WHITE LAKE TOWNSHIP
INTER-OFFICE MEMORANDUM
COMMUNITY DEVELOPMENT DEPARTMENT

SUBJECT: **Edendale Crossing**
Final Site Plan Approval
Property described as parcel number 12-29-476-025, located at the northwest corner of Bogie Lake Road and Cedar Island Road, consisting of approximately 45.47 acres.

RE: Edendale Crossing
Final Site Plan Submission

Bogie Lake Road Entrance Plan
"EDENDALE CROSSING" SITE CONDOMINIUM
PART OF THE SOUTHEAST 1/4 OF SECTION 29, T3N, R8E
WHITE LAKE TOWNSHIP, OAKLAND COUNTY, MICHIGAN

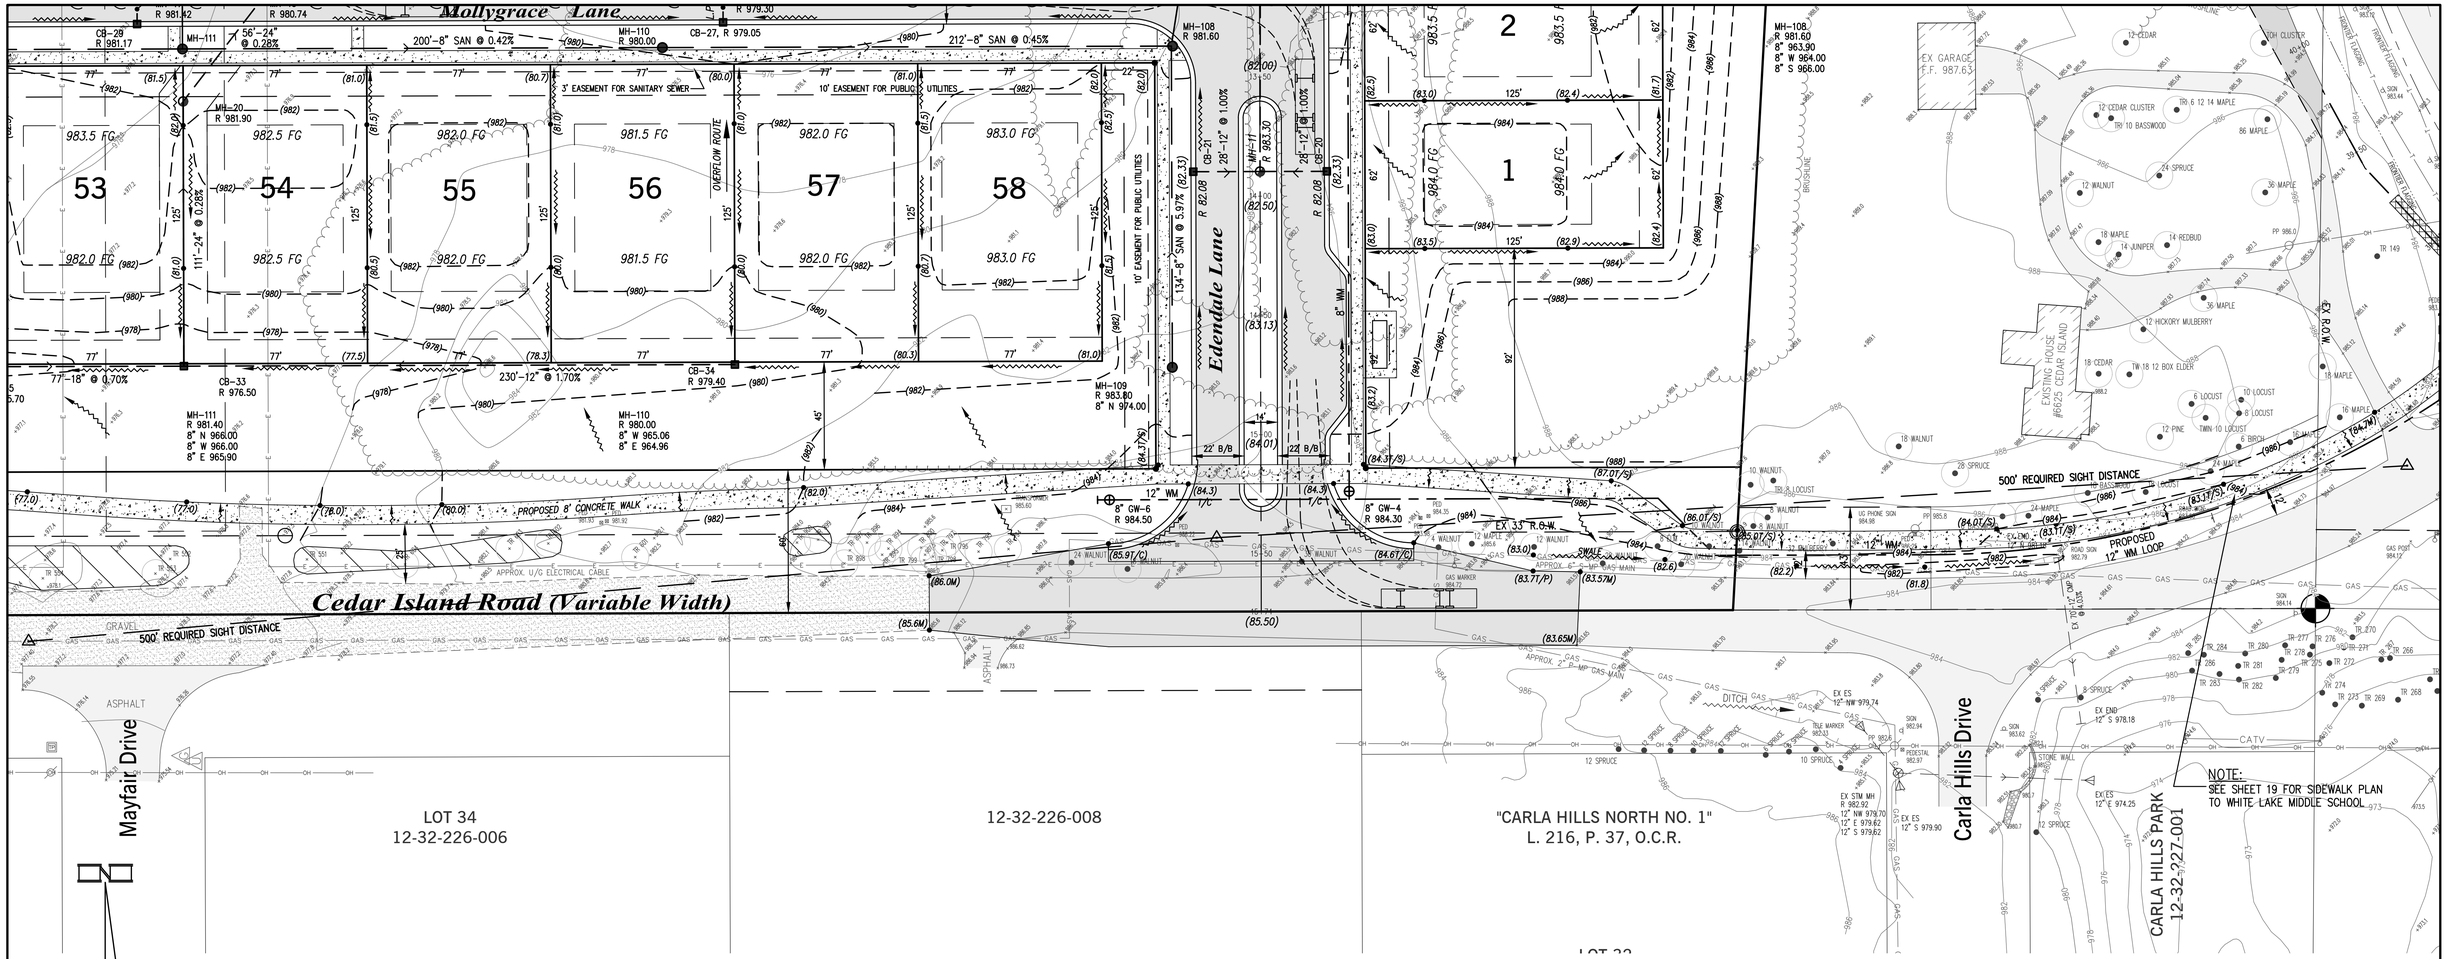
1. *Sheet 8- It appears the discharge from the detention pond will flow across Parcel #12-28-303-001 which may require a storm drainage easement unless the storm sewer can be extended to a point there is no conflict. Comment addressed. A ditch that will route where the drainage to Thompson Lake goes is now proposed within the existing road ROW.* **Comment remains as a notation.**

2. *Sheet 8- The proposed storm sewer layout along Bogie Lake Road will need to be* ***clarified at the time of ~~Final Site Plan/~~Final Engineering Plan*** *to work with existing stormwater features, site drainage, and utility poles etc.* **Comment remains as a notation.**

Cedar Island Entrance Plan
"EDENDALE CROSSING" SITE CONDOMINIUM
PART OF THE SOUTHEAST 1/4 OF SECTION 29, T3N, R8E
WHITE LAKE TOWNSHIP, OAKLAND COUNTY, MICHIGAN

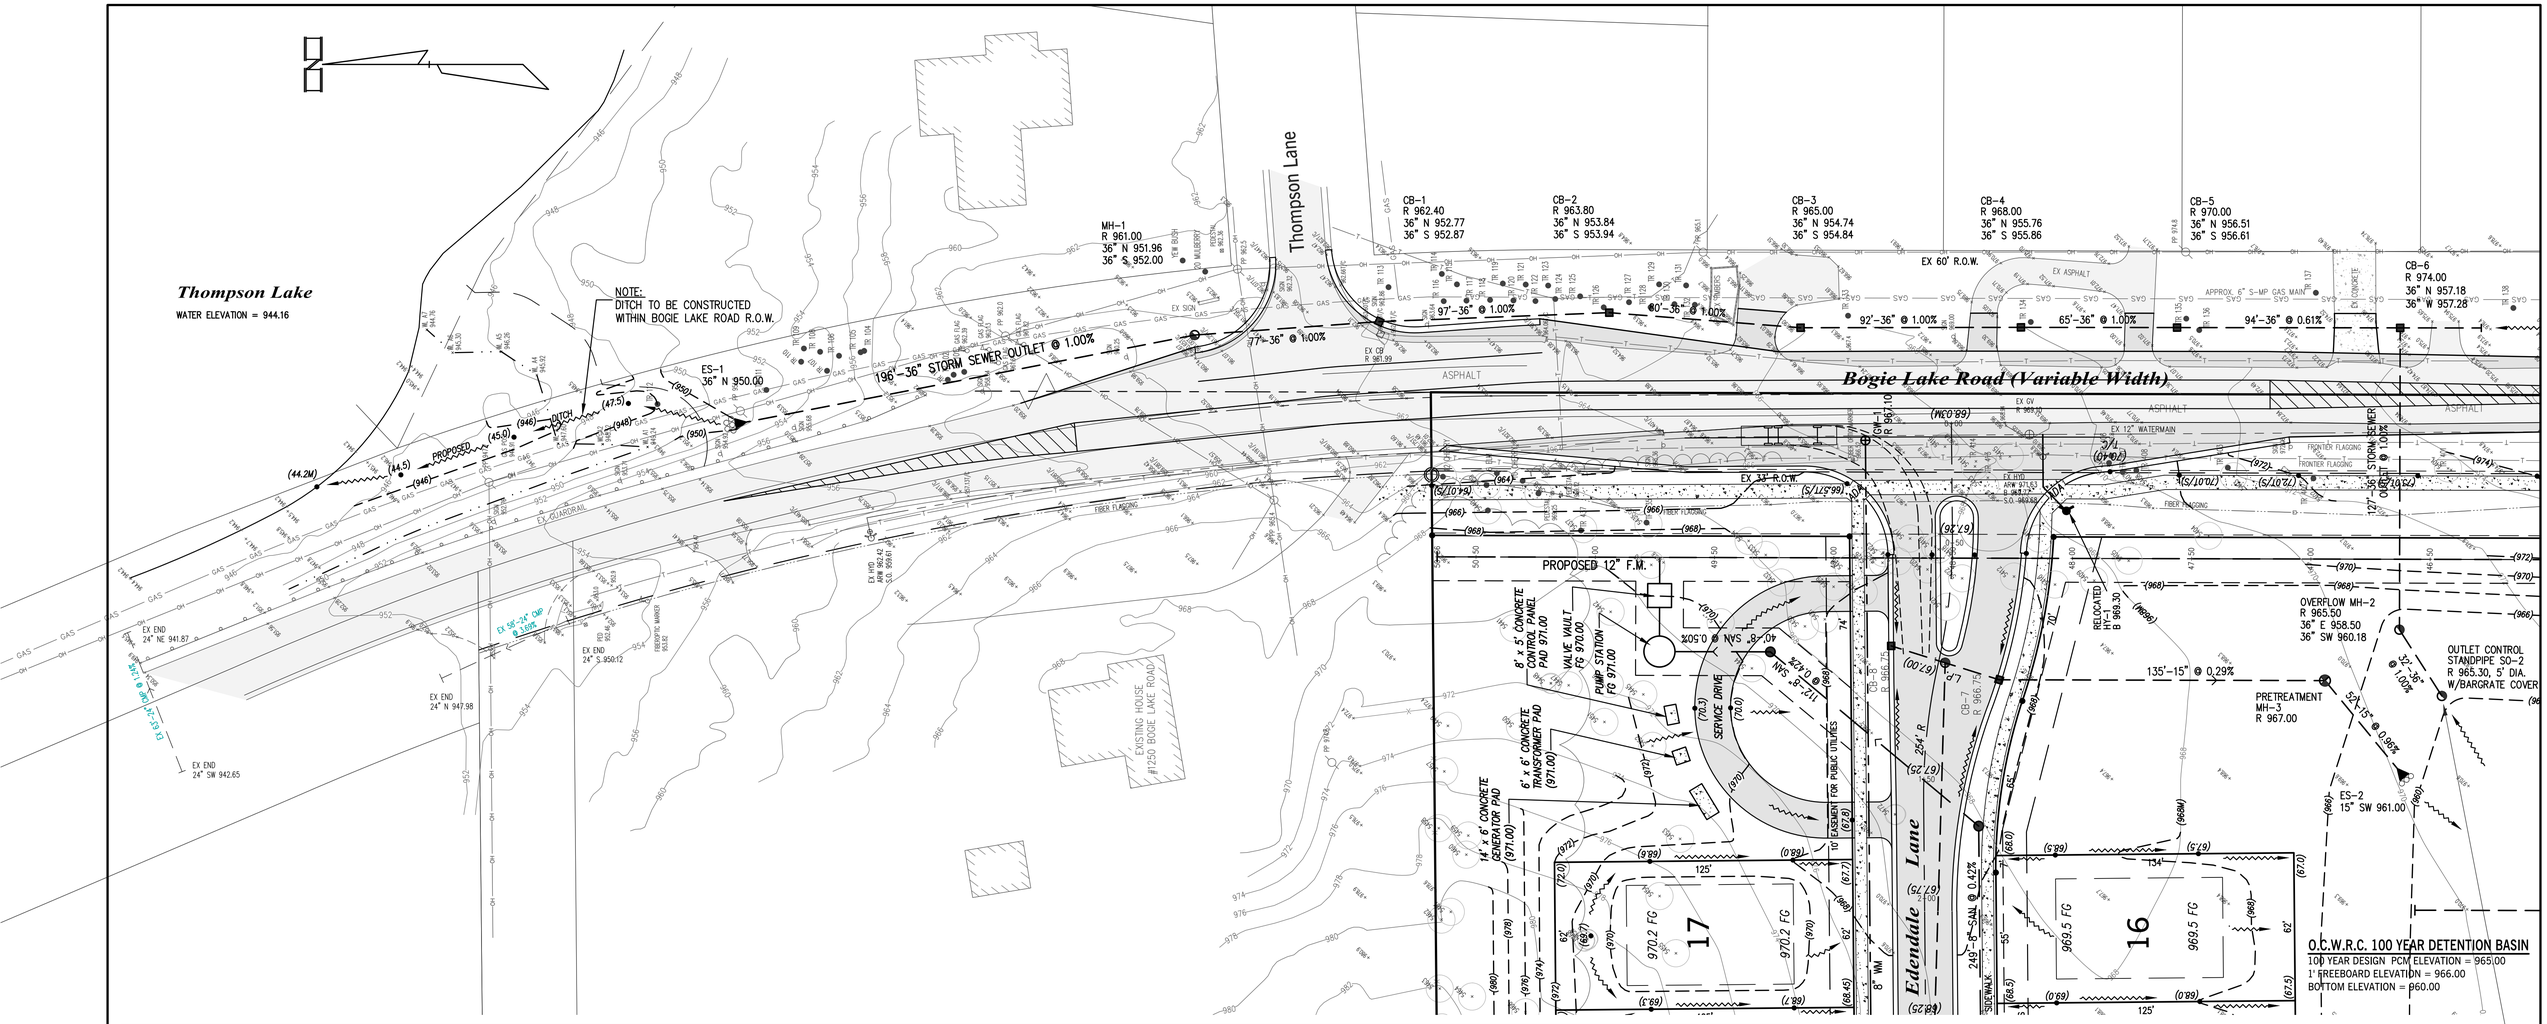
6. *Sheets 5 and 9- Entrance dimensions of Edendale Lane at Cedar Island Road do not correspond to 21' B/B and 16' (island width) when measured per provided scale. Please revise.* **Entrance dimensions have been adjusted to 22' B/B widths.**

Detention Basin Calculations & Details "EDENDALE CROSSING" SITE CONDOMINIUM

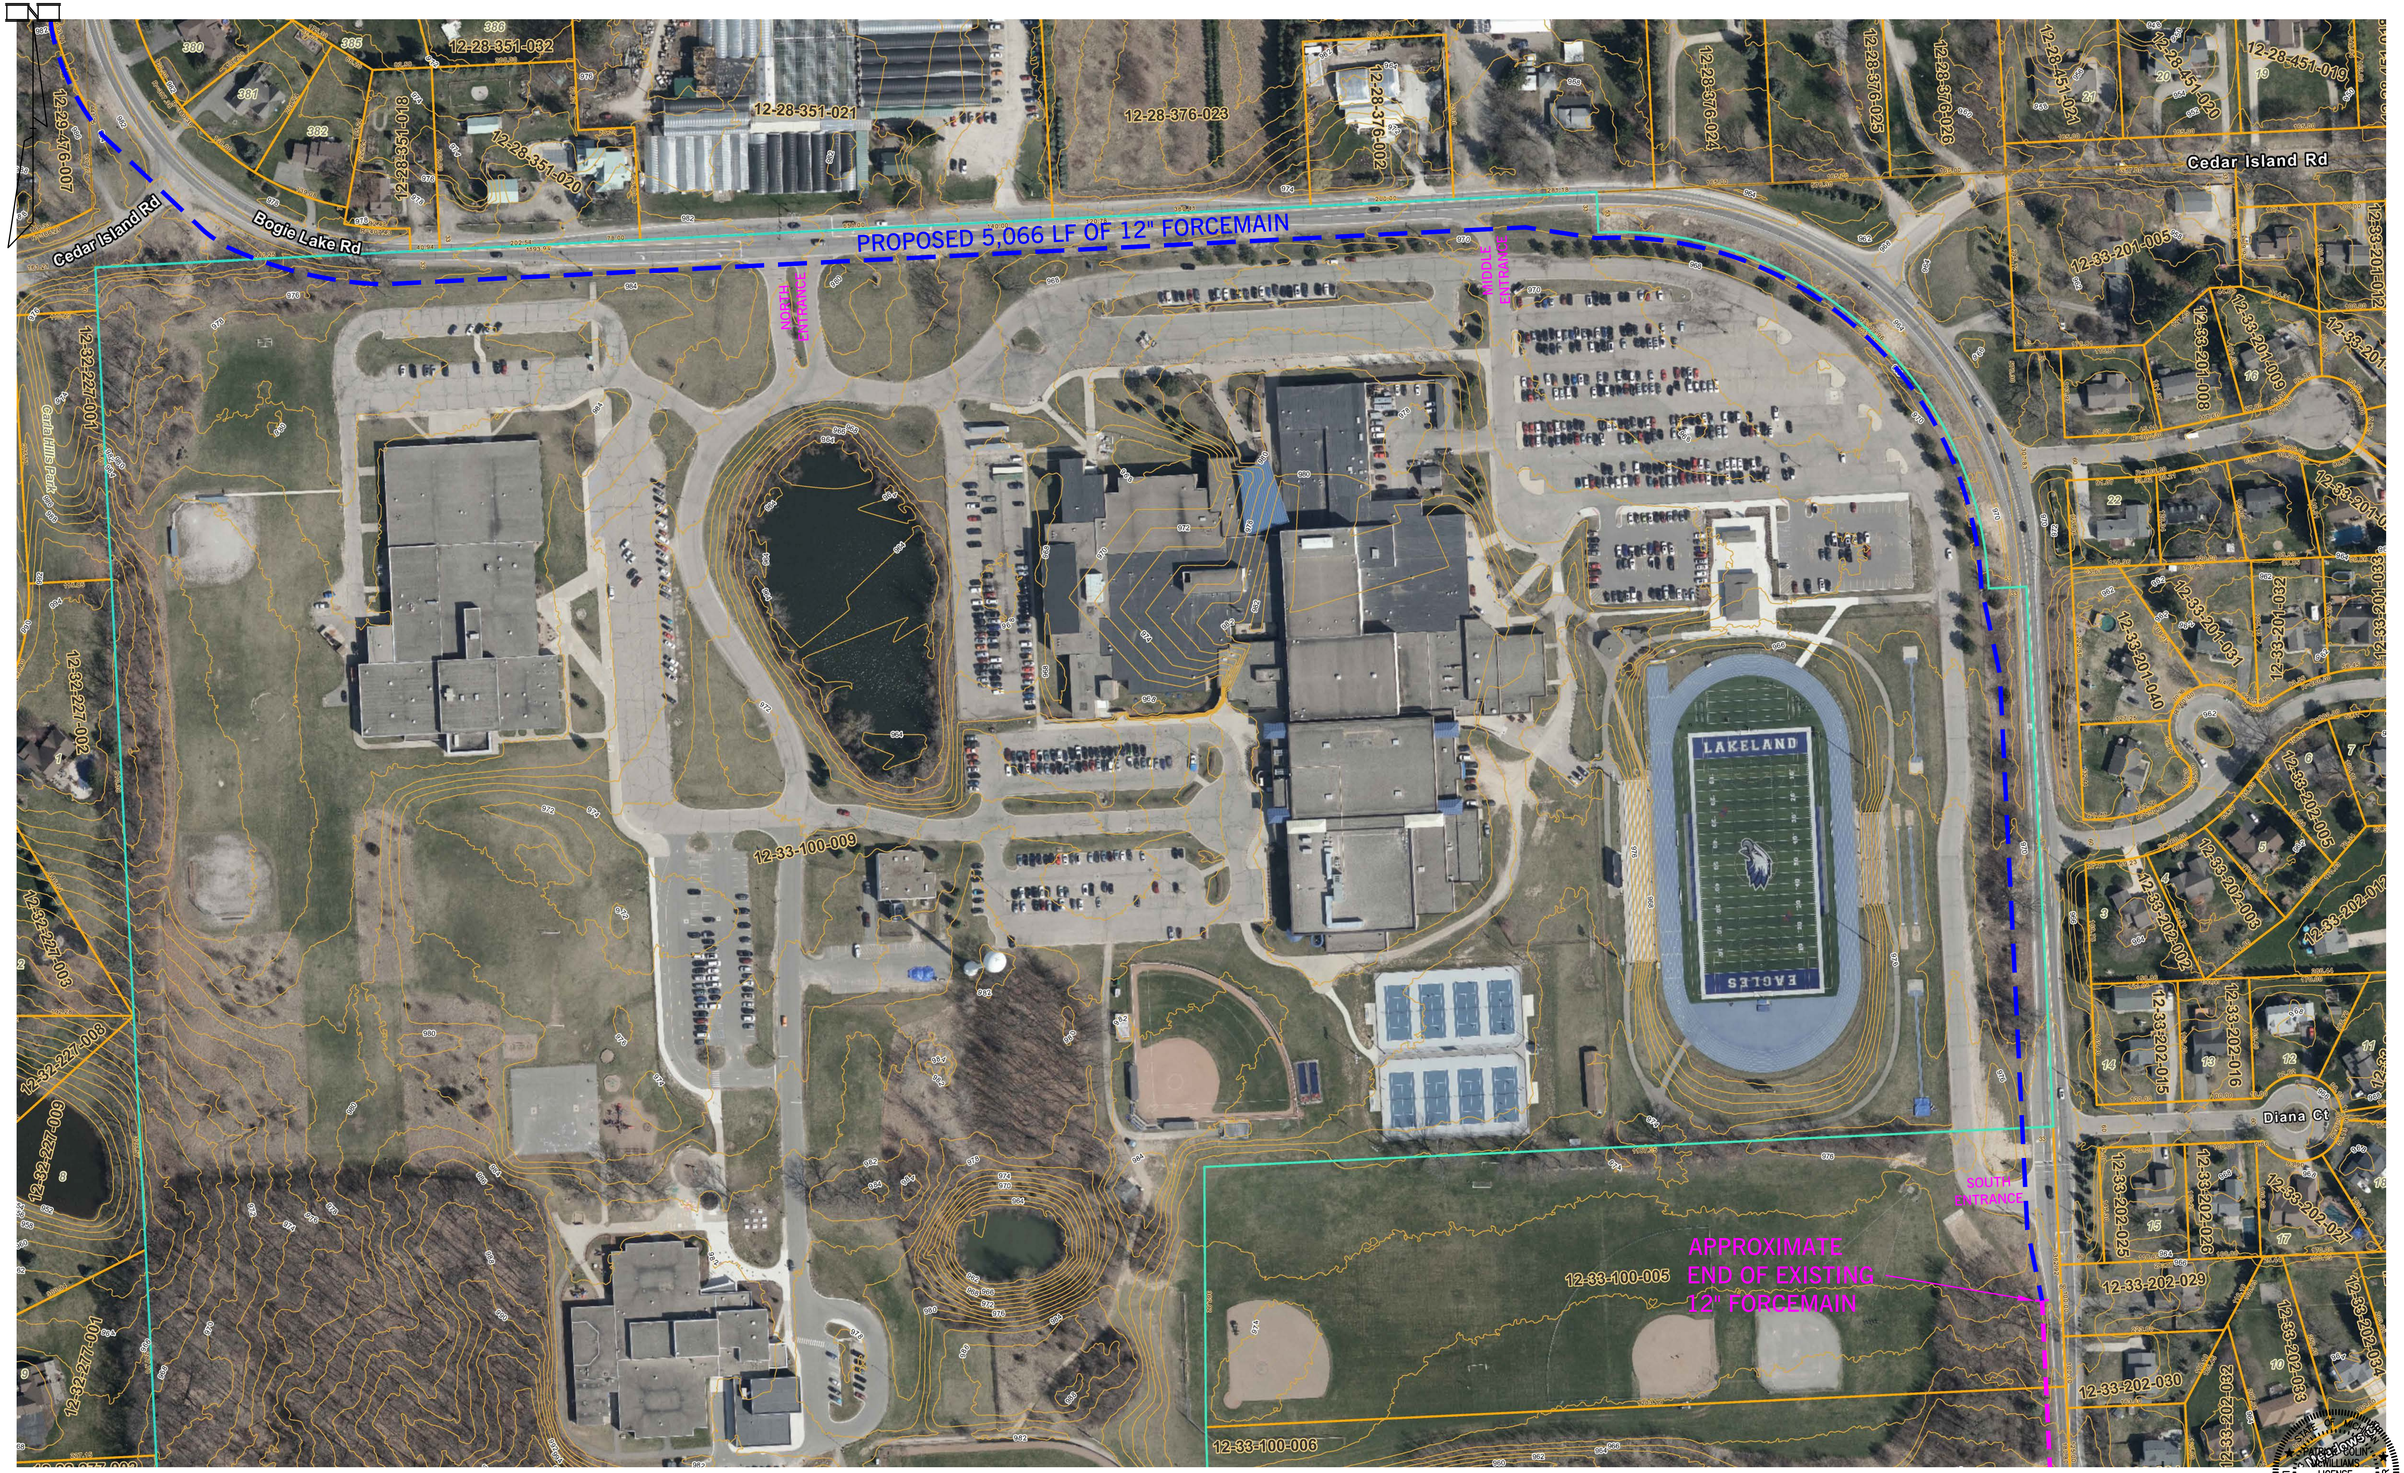
1. Sheet 11- Please see marked up calculations for revisions that shall be required.
2. We note that the location of the proposed sanitary pump station has changed from the Township Board approved Preliminary Site Plan. We consider the revised orientation to be an improvement compared to what was previously indicated so we do not take issue with this item but wanted to note the change.

Does not match C (0.41)provided on Sheet 3

Shown on Sheet 3 as 3.20 acres

In addition, Sheet reference note on Sheet 3 references Sheet 16; it should be Sheet 11.
